Tarheel Lodging Redevelopment

Certificate of Appropriateness Phase-II Modifications

August 23, 2022

14UPDATED 8-30-22; 2nd Submittal Revised 11-8-22

OAS-7
Layout &
Planting Plan

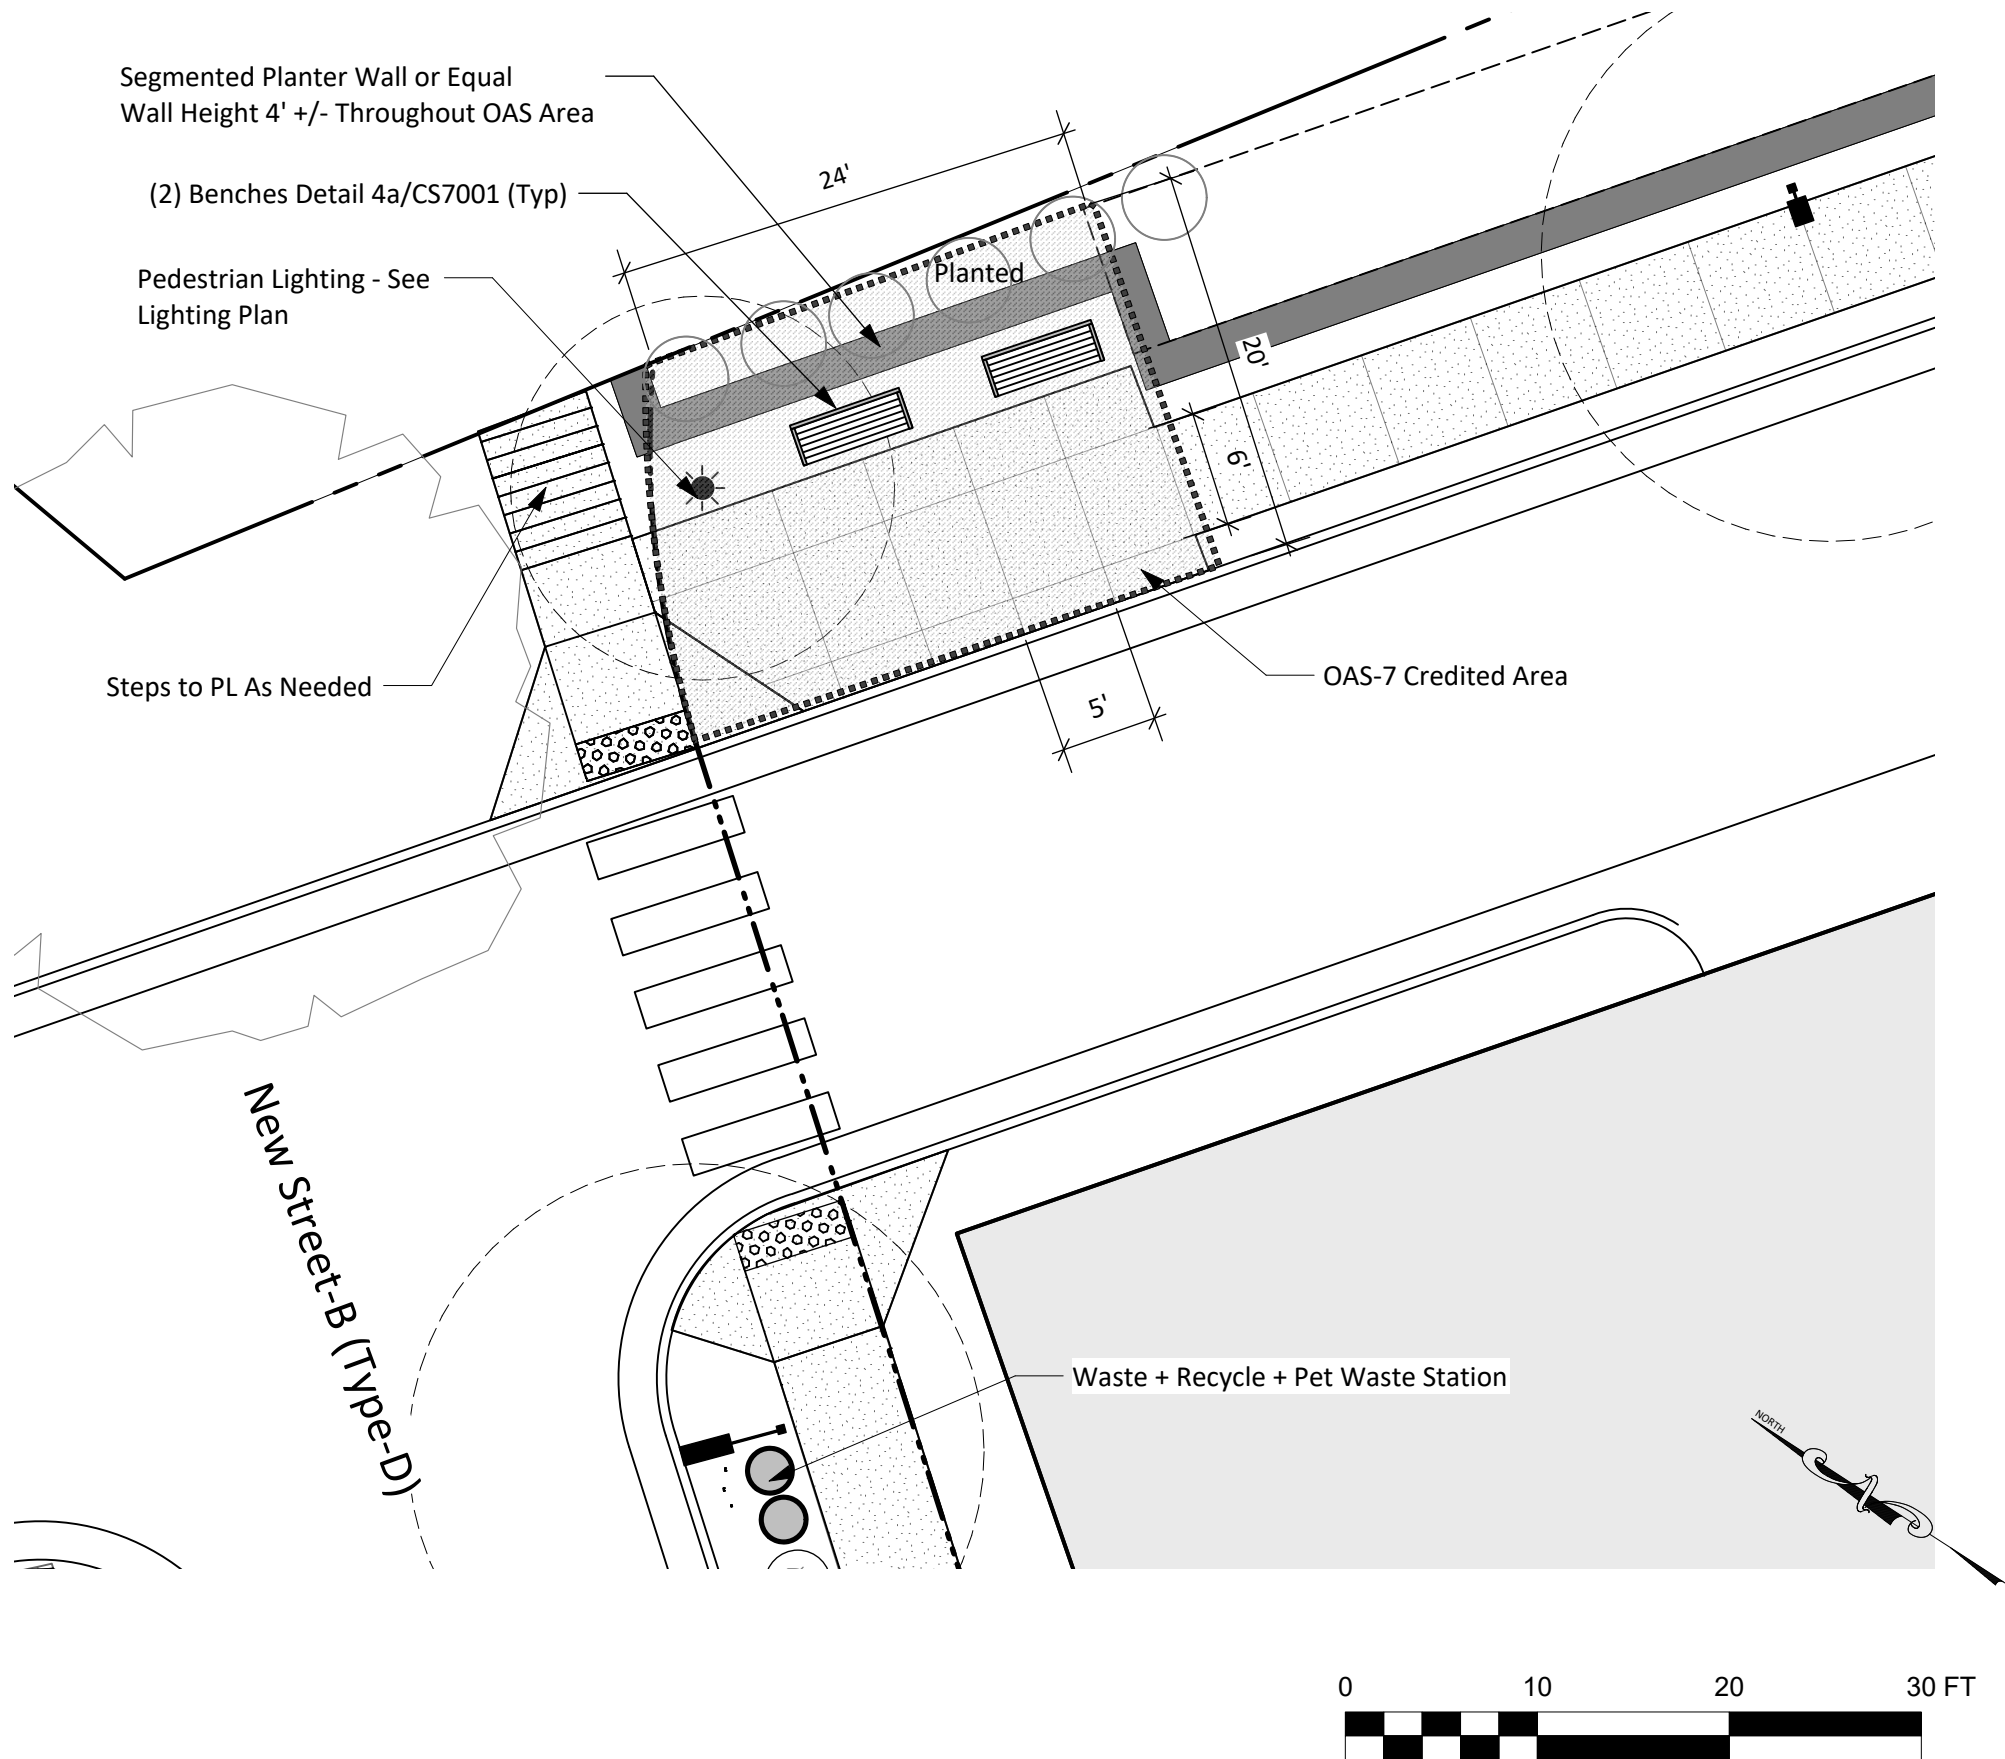
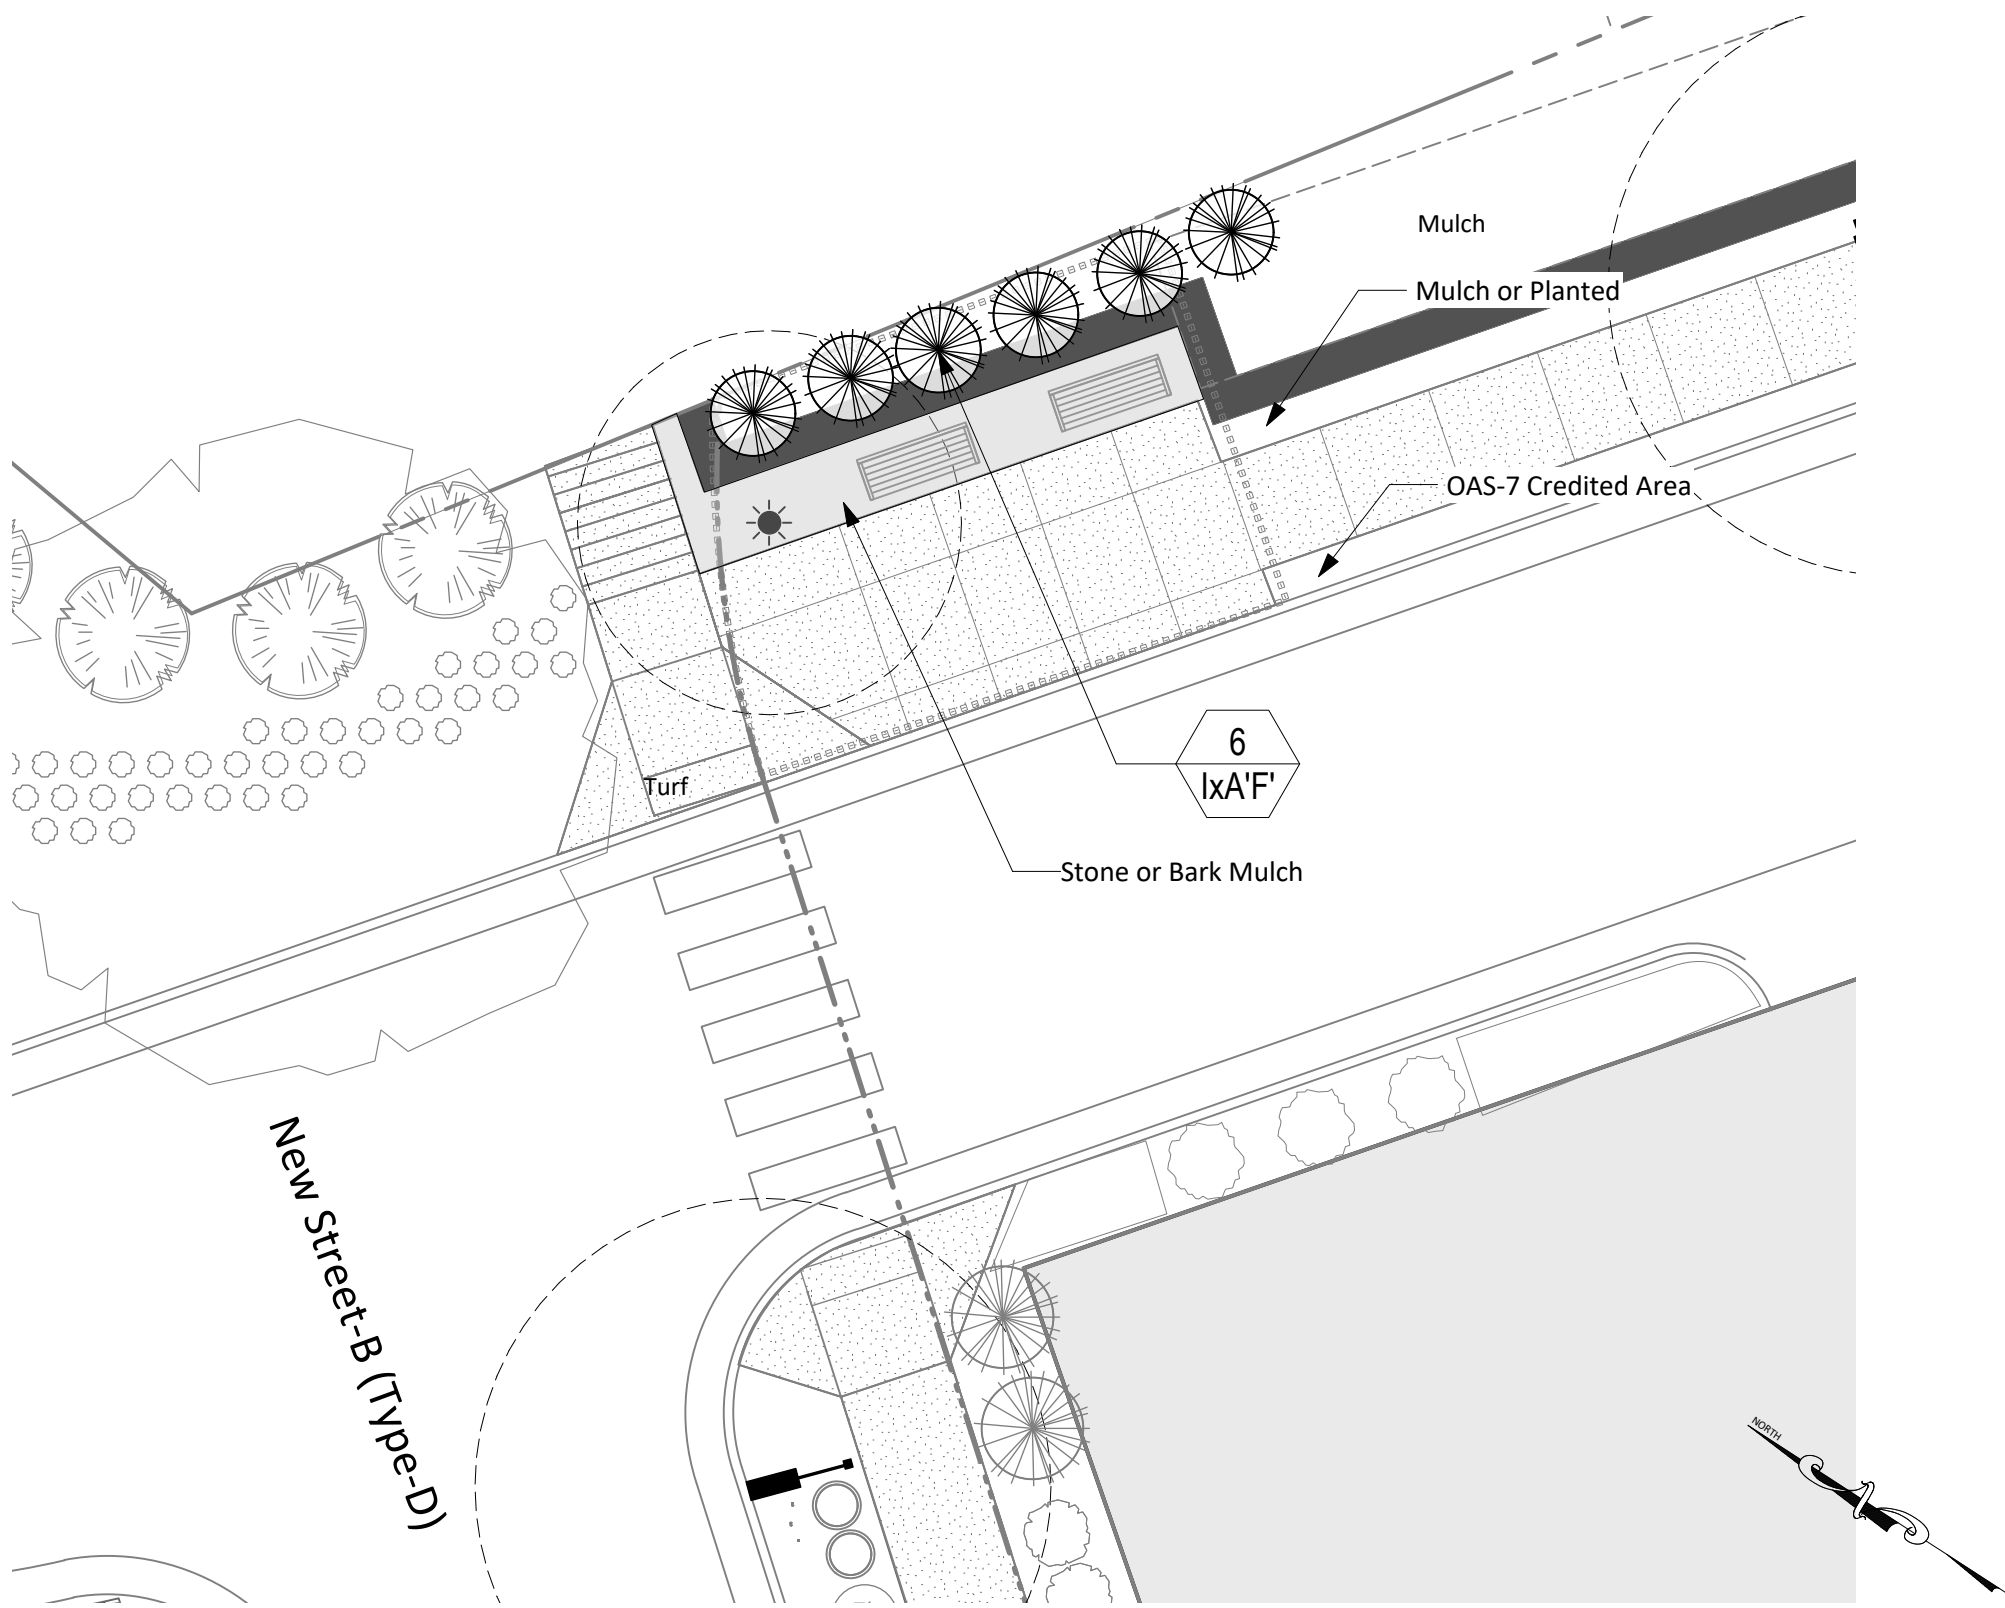
2	10-14-22	Revise OAS-7
1	8-30-33	Phase-II Modifications
No.	Date:	Issue Notes:

OAS-8
Layout &
Planting Plan

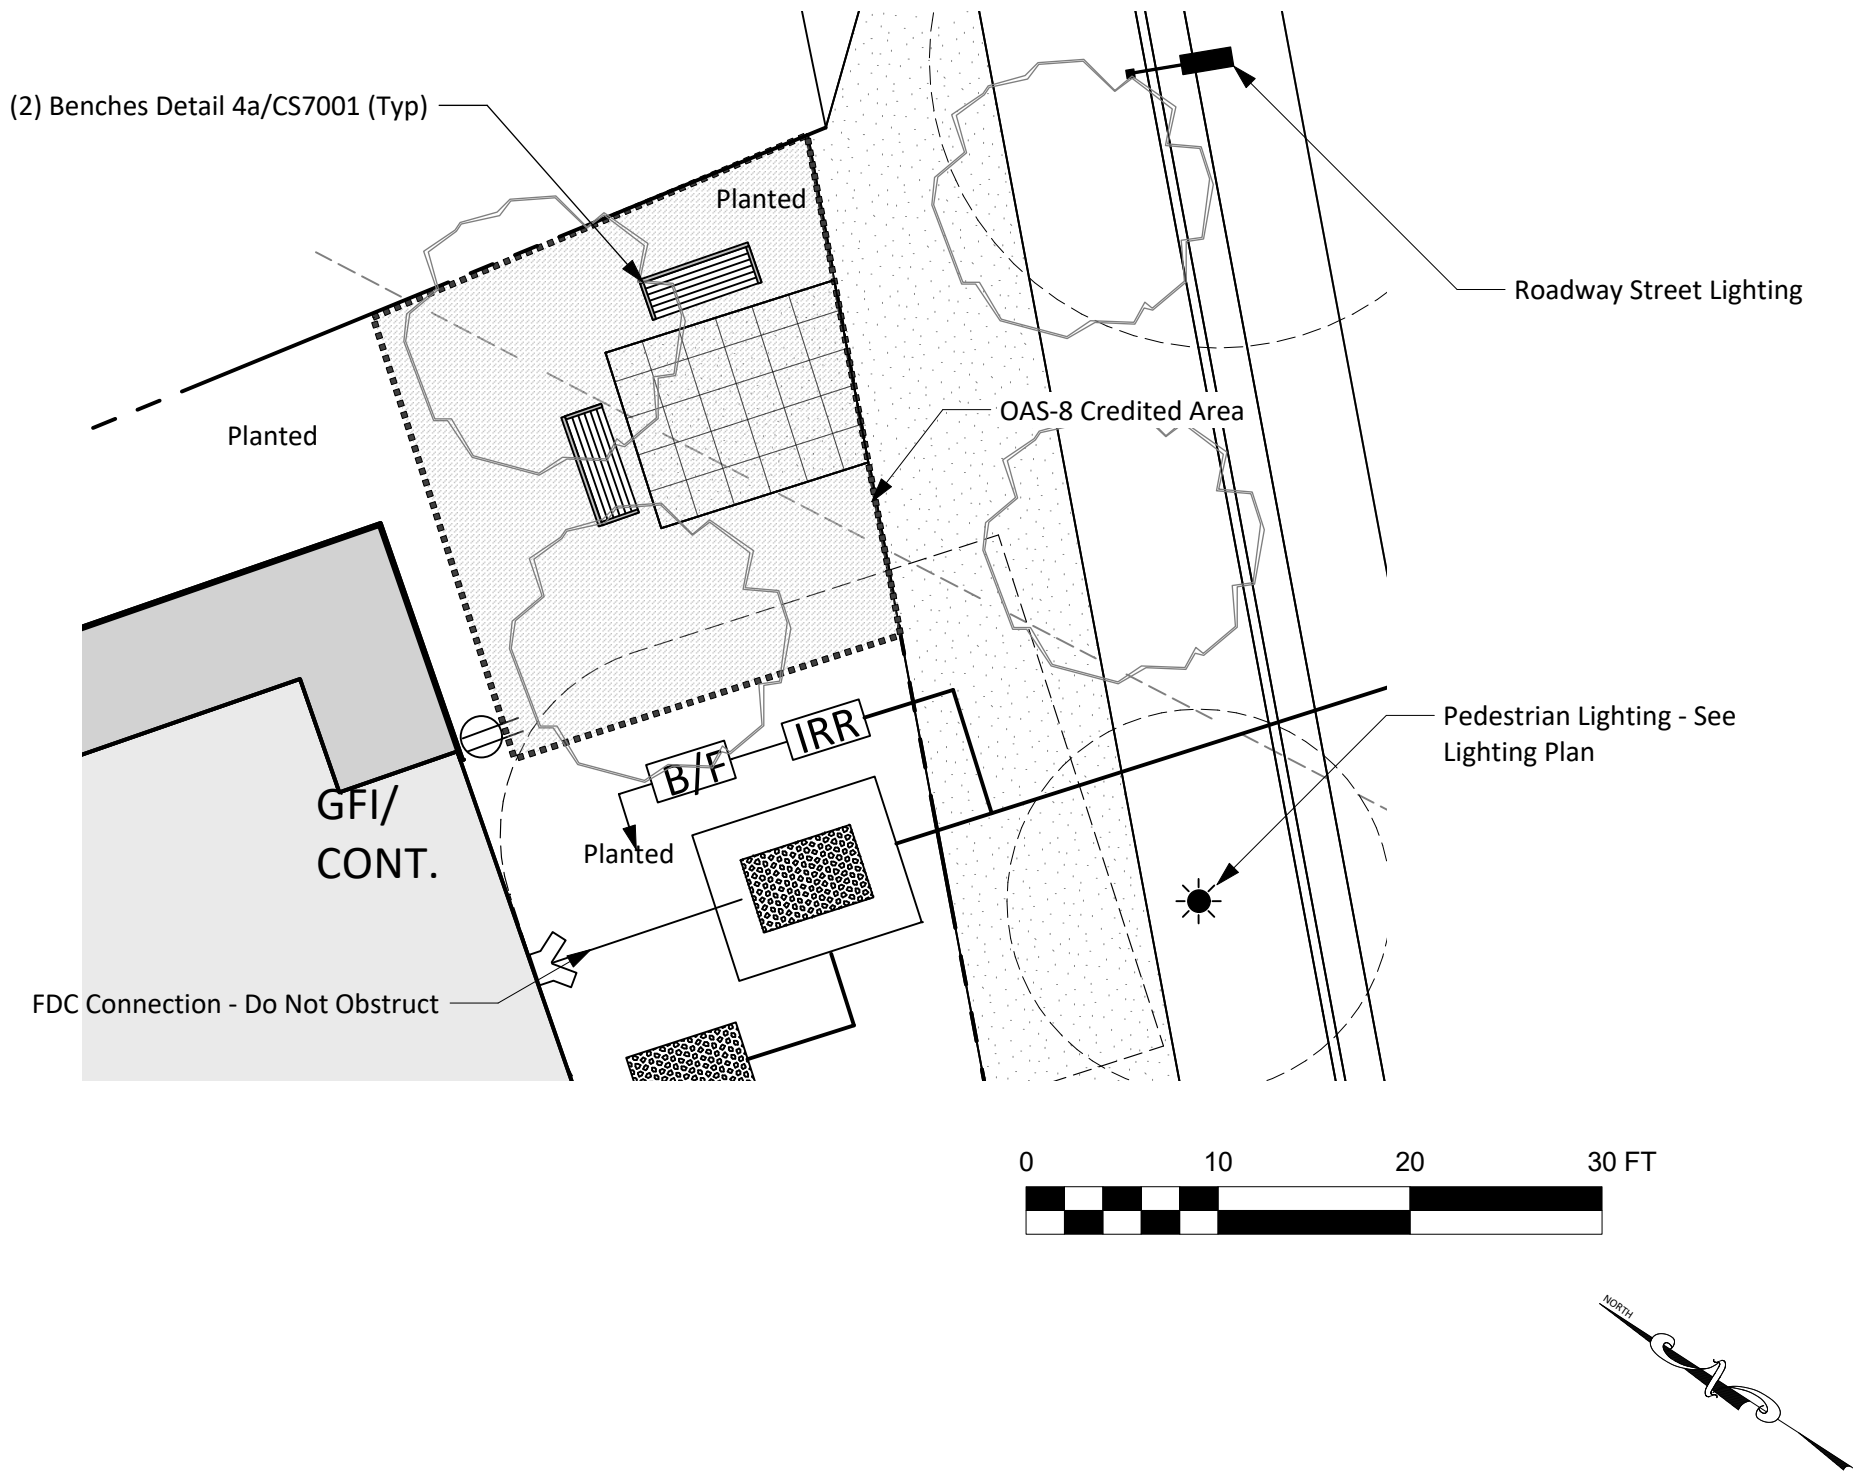
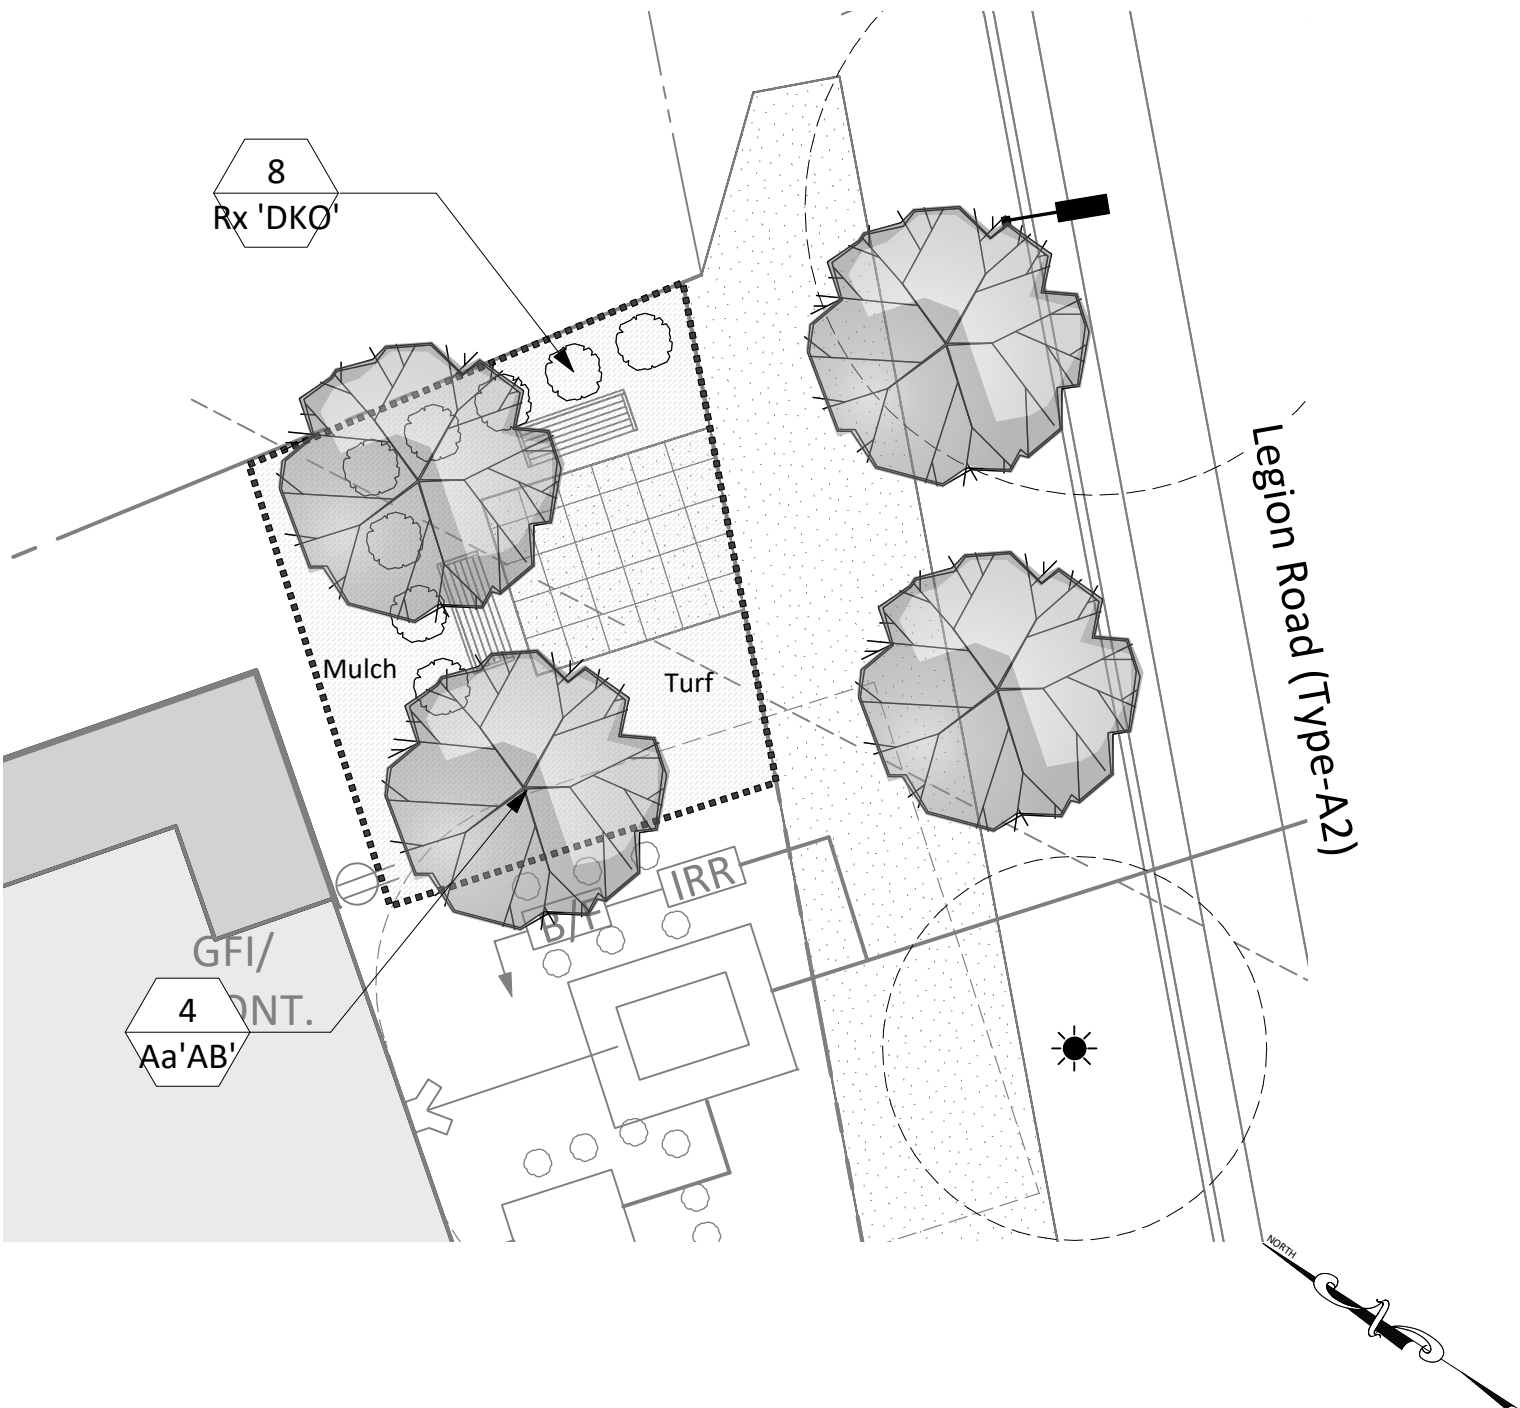
1	10-14-22	Phase-II Modifications OAS-8 Added
No.	Date:	Issue Notes:
